# CONSERVATION COMMISSION AGENDA

The Conservation Commission will hold this meeting as a virtual meeting on Thursday, August 27, 2020 at 7:00 pm. No in-person meeting will take place at City Hall.

1. **Presentation – Connector Stairs at Norumbega – Eagle Scout Project**
  - Owners: City of Newton Applicant: Alex Morefield
  - Request: Eagle Scout candidate Alex Morefield will present his proposal for installing box stairs in Norumbega Conservation Area

# 35 SPIERS RD - PROPOSED CONDITIONS

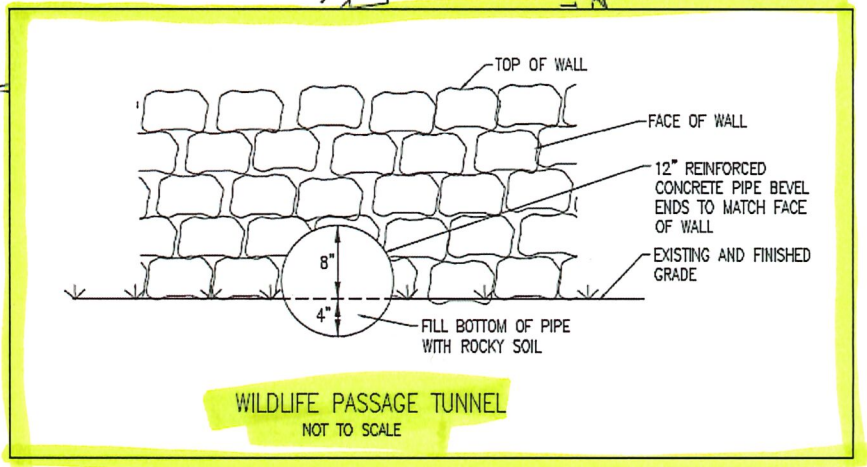
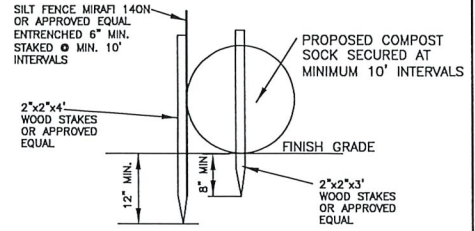
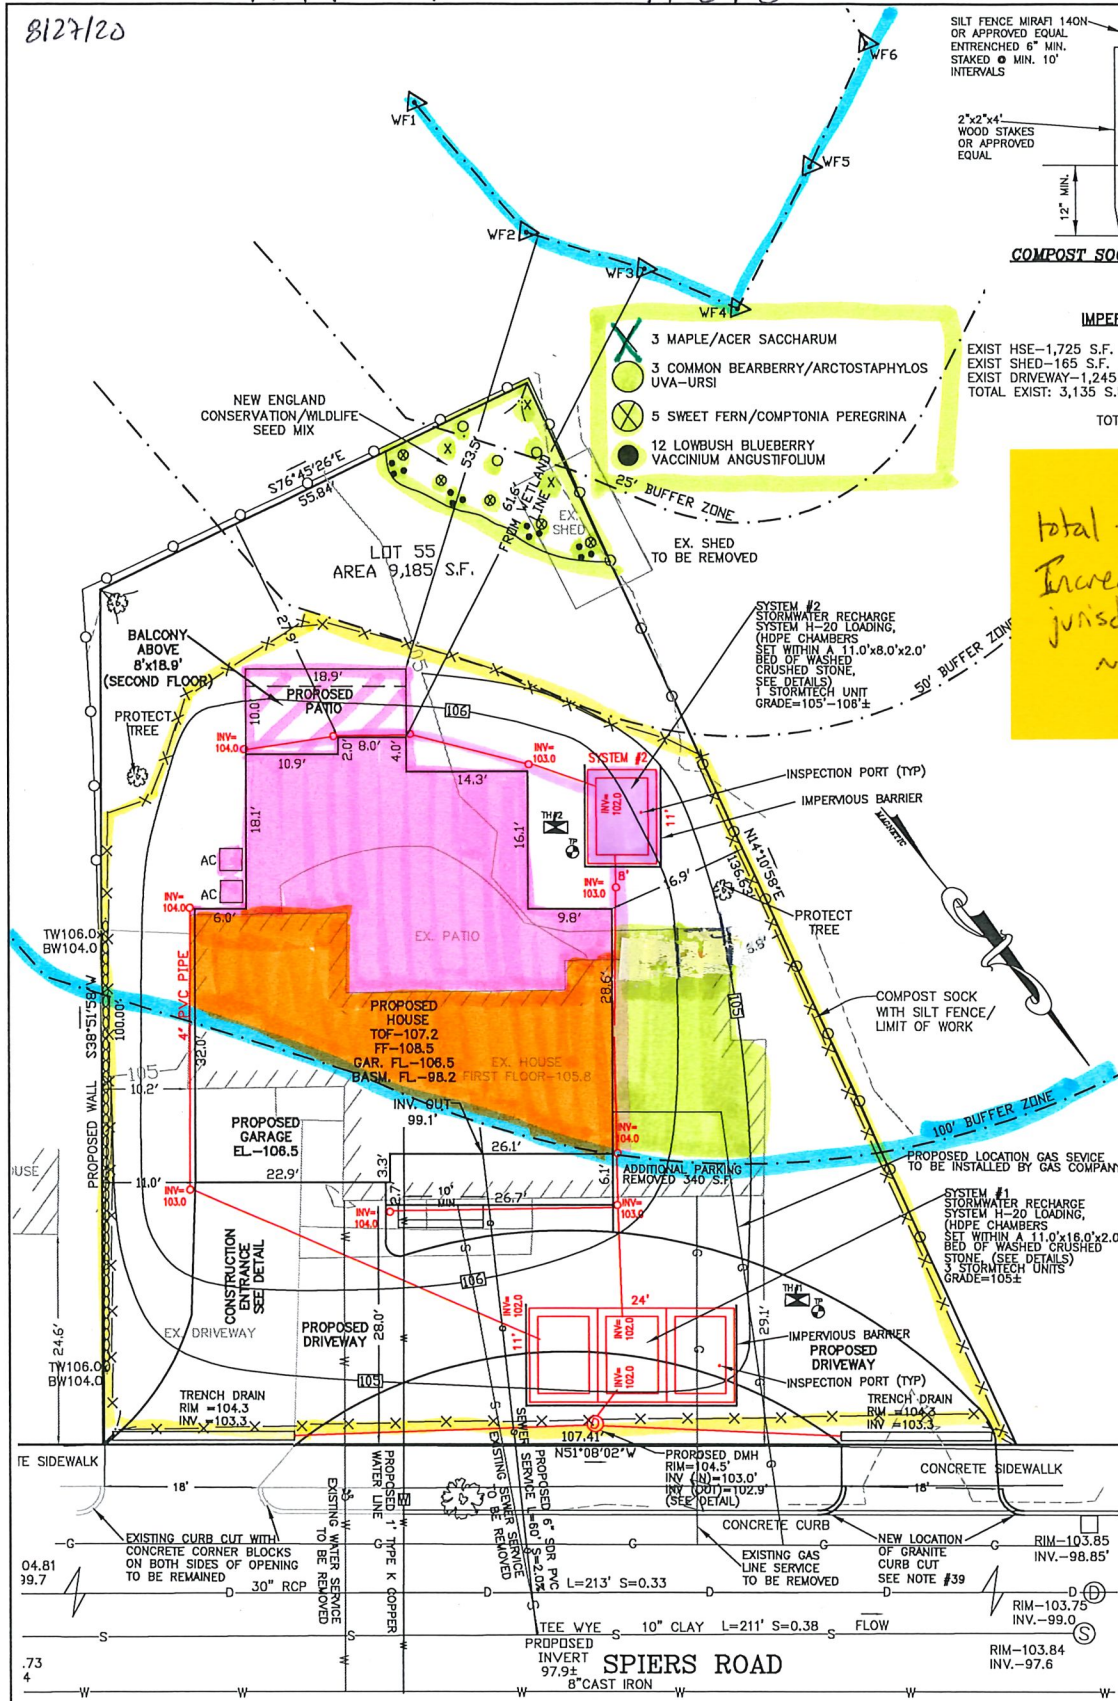
- Replace existing fence.
  - Staff Notes
    - Applicant stated at the last meeting that the limit of work line is workable, but staff still feel it is unrealistically close to the edge of grading, excavation, and construction.

- A note regarding tree protection has been added to the plans. A detail for tree protection has been provided but in an informal presentation. Staff have required that tree protection be shown on the plans to demonstrate that the proposed tree protection (with fence at the dripline) will disrupt the proposed erosion control line due to the size of the maple in the rear yard.

- Applicant has added 12 lowbush blueberries to the mitigation planting plan.
    - Staff have concerns about the arrangement of plants, with the sweet fern and lowbush blueberry at the front of the area, are sufficient to properly demarcate a mitigation planting area. The Commission should consider if they

would like some of the maple saplings moved to the front or have a small landscape fence installed until a Certificate of Compliance ensures survival to more clearly demarcate the natural area not to be mowed.

- **Staff Recommendations:** If appropriate revisions regarding erosion control and tree protection are received prior to the meeting, vote to close the hearing and issue an Order of Conditions with the following special conditions.
  - Should any of the three trees on the lot die within two years of construction or are shown to have been demonstrably harmed by the construction, these trees will be replaced at a ratio of 2:1.
  - Tree protection shall include orange snow fence installed along the dripline of the tree.
  - All landscape plantings must survive two growing seasons at 100%.
  - The new fence installed on the site must be elevated 6" from the ground to allow for wildlife passage.

# 791 WALNUT ST - POND 1 TREE / VEG. REMOVAL

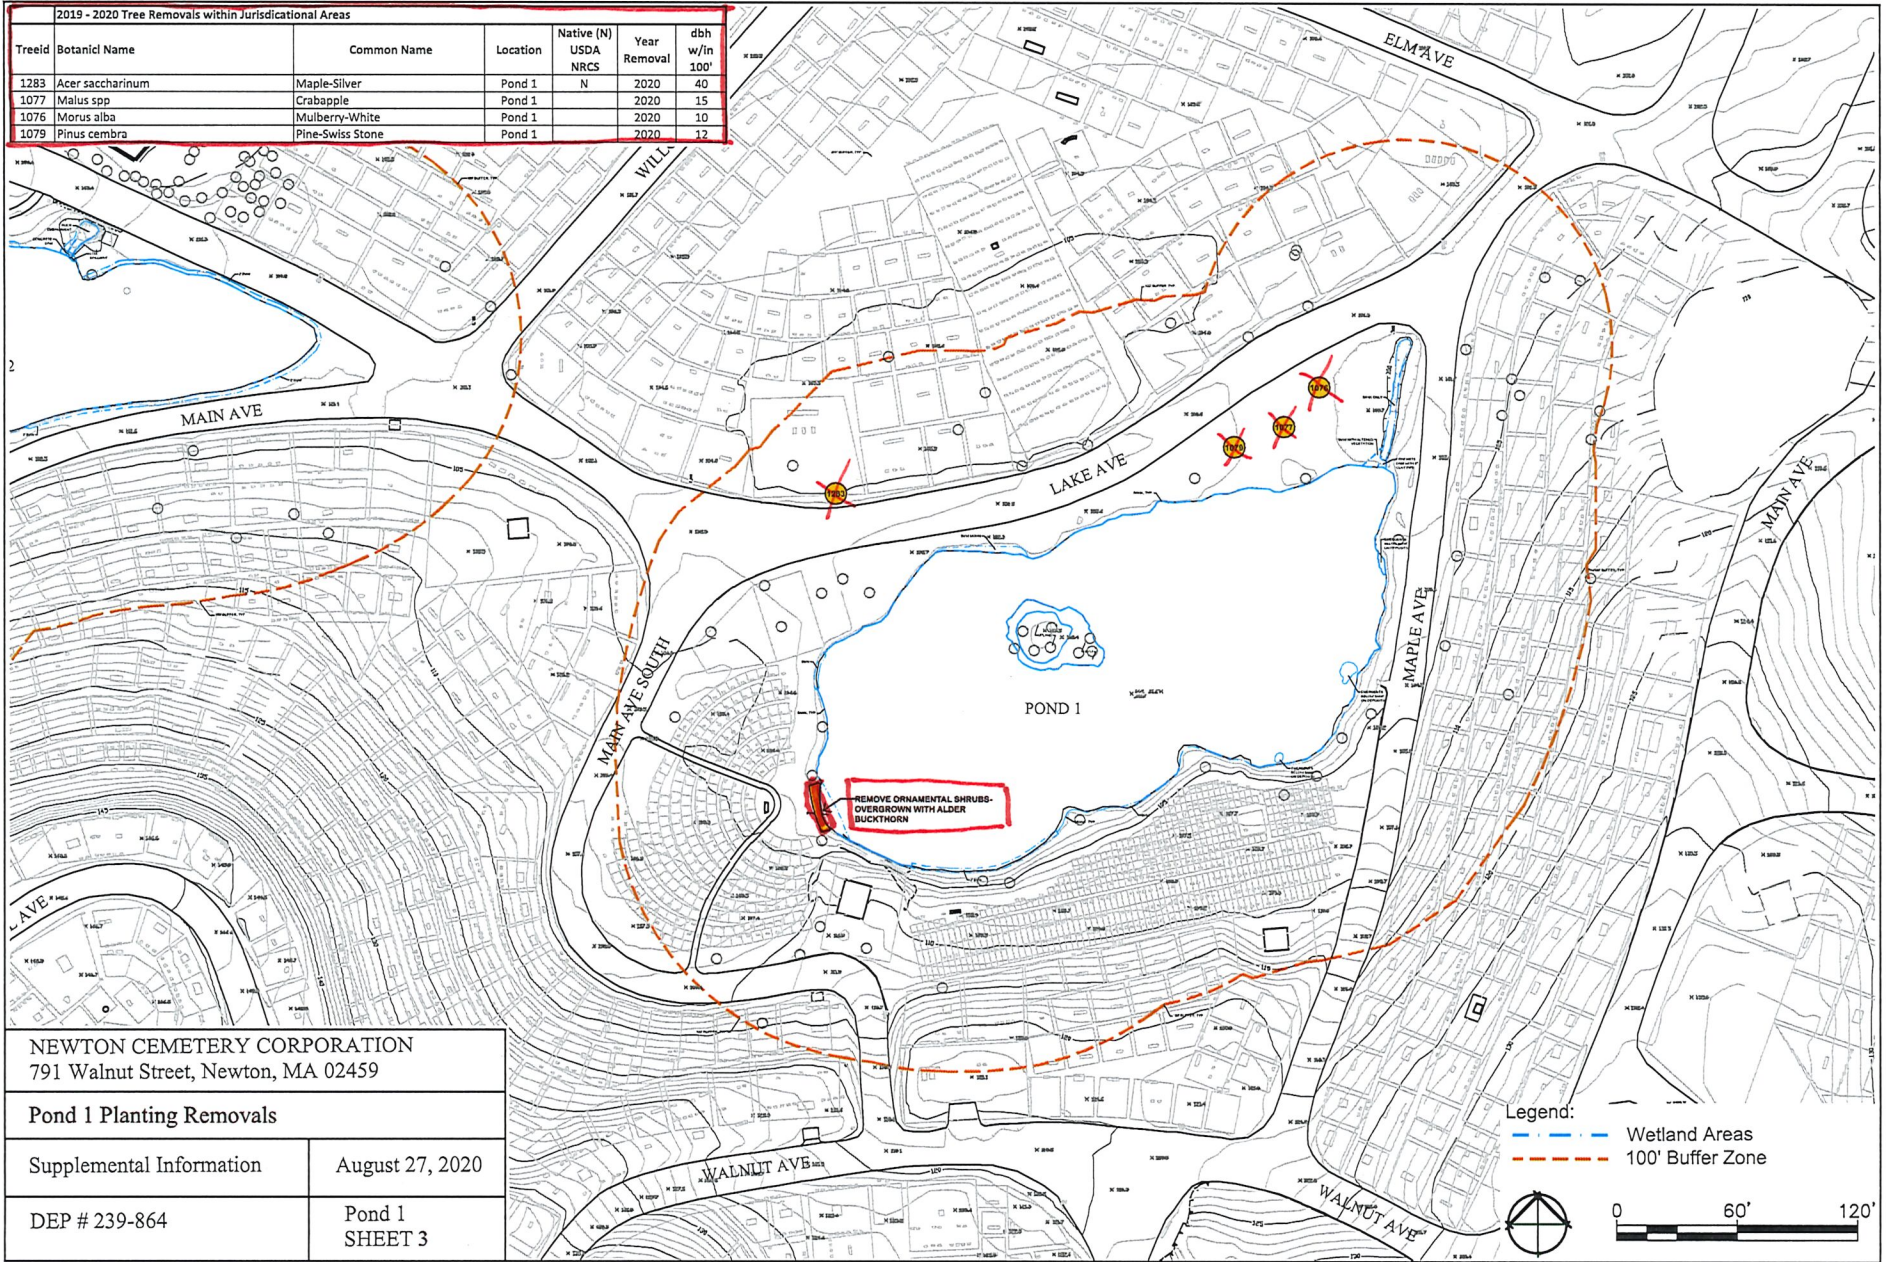
- **Staff Notes**
  - Applicant should clarify if any further tree removal is proposed or if all/some of the trees listed as "removed in 2020" are still standing.
